The Commission has issued the enclosed Amendment Nos. 51, 51 and 48 for License Nos. DPR-38, DPR-47 and DPR-55 for the Oconee Nuclear Station, Units 1, 2 and 3. These amendments consist of changes to the Stations common Technical Specifications and are in response to your request dated June 6, 1977.

These amendments revise the common Oconee Technical Specifications to incorporate changes to the Oconee Unit 2 pressurization heatup and cooldown limitations.

ATTACHMENT TO LICENSE AMENDMENTS

SAFETY EVALUATION BY THE OFFICE OF NUCLEAR REACTOR REGULATION

Figure 3.1.2-2B

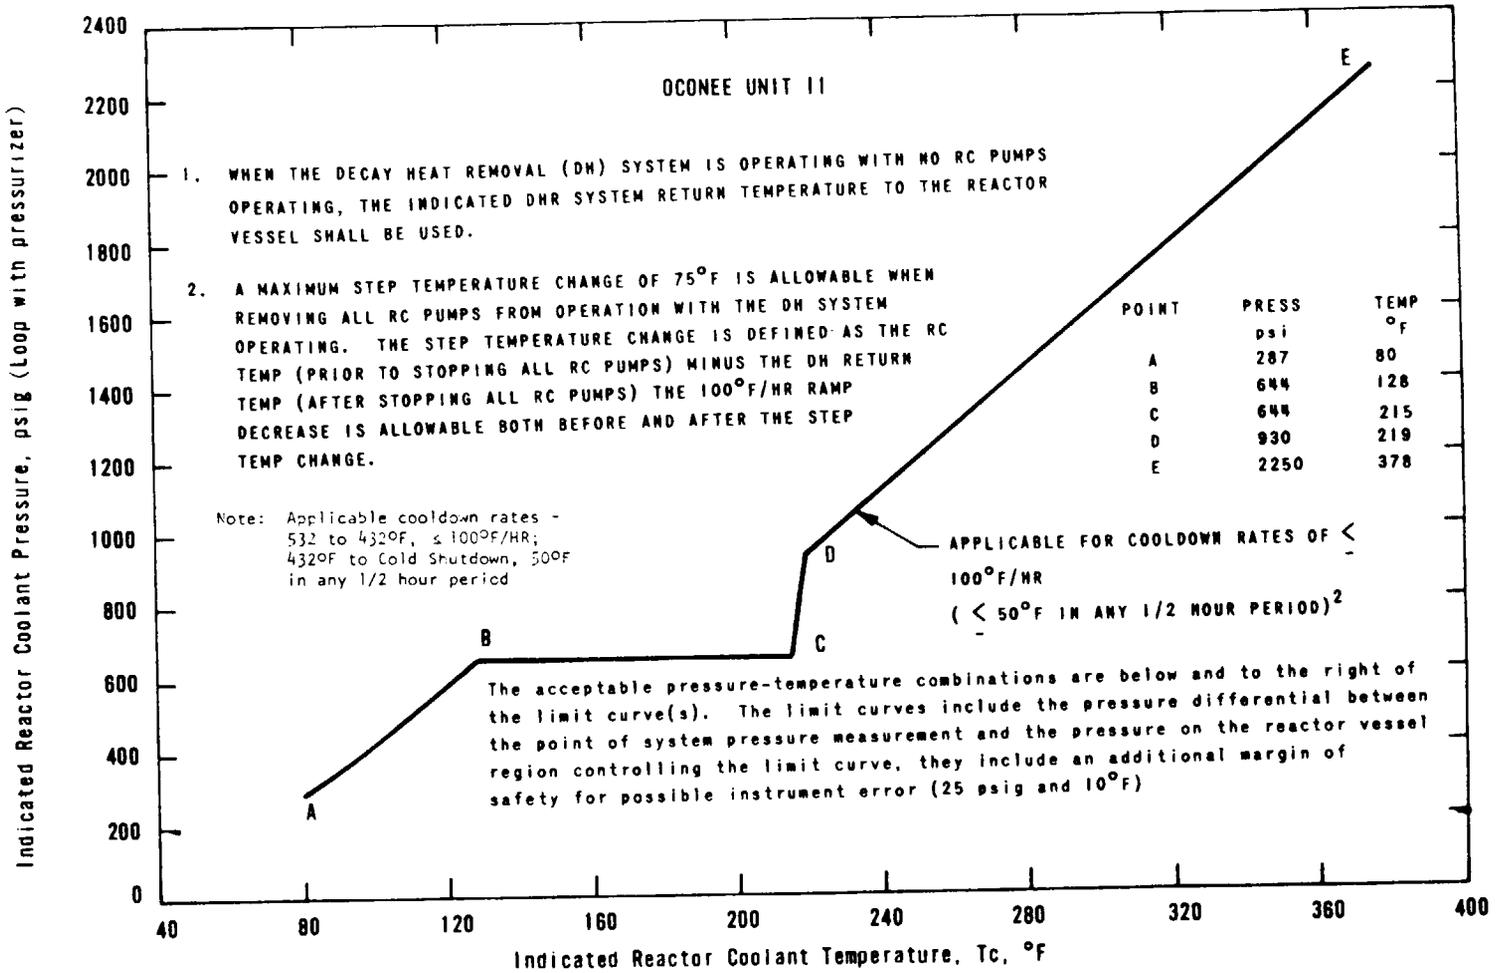
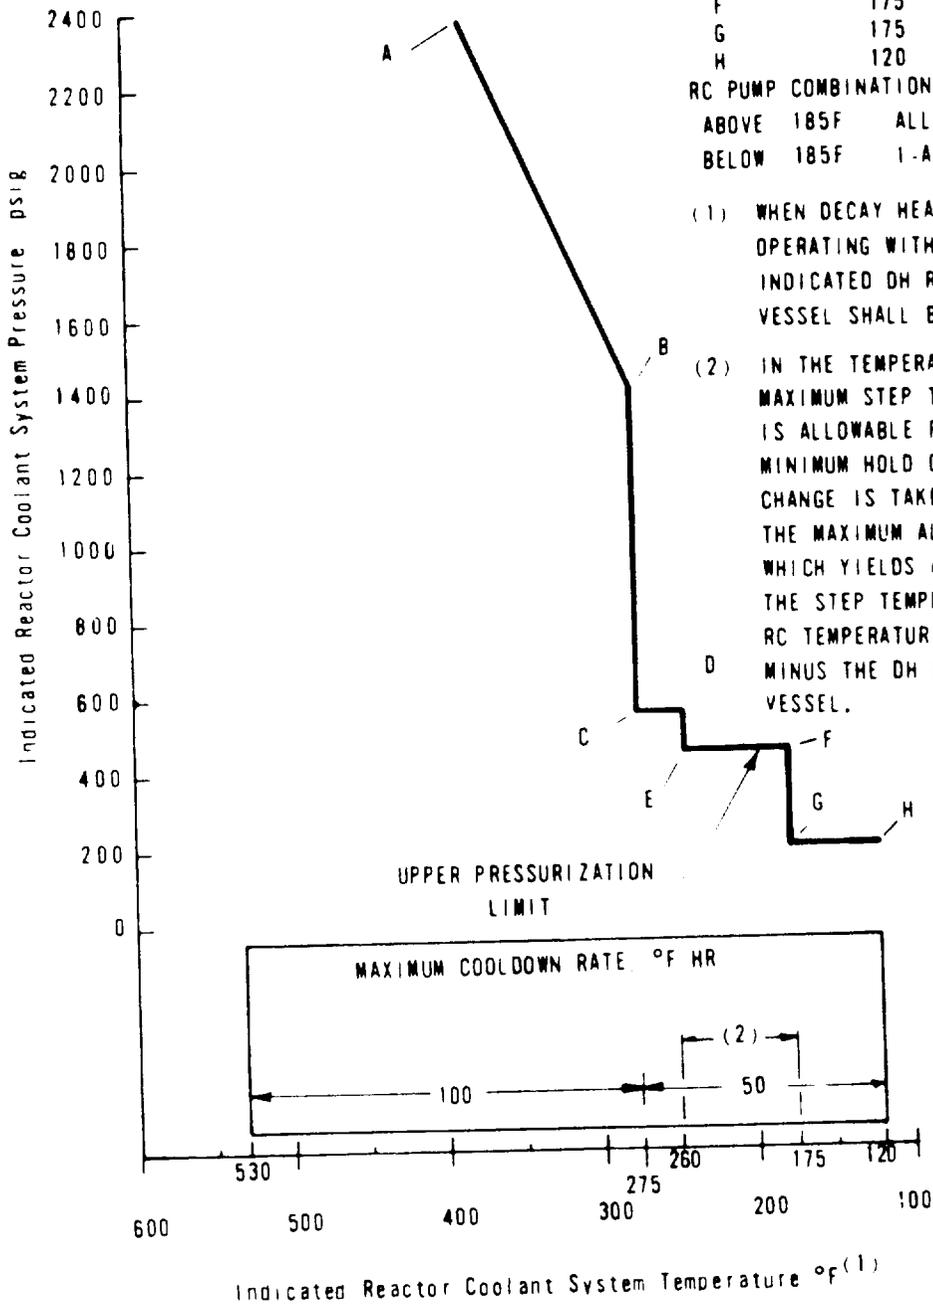
The proposed revised Oconee Unit 2 pressure-temperature operating limit curves, Figures 3.1.2-1B, 3.1.2-2B and 3.1.2-3B are based on data from Babcock & Wilcox Report, "Analysis of Capsule OCII-C From Duke Power Company Oconee Nuclear Station, Unit 2, Reactor Vessel Materials Surveillance Program," BAW-1437, dated May 1977. The proposed curves are projected for 6 EFPY.

We have reviewed BAW-1437 and the proposed pressure-temperature operating limit curves. Capsule C from Unit 2 contained specimens of weld metal WF 209-1. This weld is not identical to the welds in Oconee Unit 2. However, this weld has a similar chemical composition and was made using weld procedure similar to those for high copper Oconee vessel welds. Therefore we conclude that the properties of the limiting weld metals in the Oconee reactor vessels will be affected by irradiation in a manner similar to these WF 209-1 specimens. Also, the Oconee Unit 2 and Unit 1 neutron flux, flux spectrum and weld material mechanical properties are similar. The Oconee Unit 1 pressure-temperature limits were approved on February 23, 1977, and were applicable for 4 EFPY. For the reasons stated in our Safety Evaluation Report issued February 23, 1977 on Oconee Unit 1, we have concluded that the proposed temperature operating limit curves for Unit 2 should also be limited to 4 EFPYs of operation.

Based on our review of the Oconee Unit 2 pressure-temperature limits and the similarity of the Oconee Unit 2 and Unit 1 designs, materials and operating conditions, we conclude that the operating limits proposed for Unit 2 are in conformance with Appendix G, 10 CFR Part 50, and are therefore acceptable.
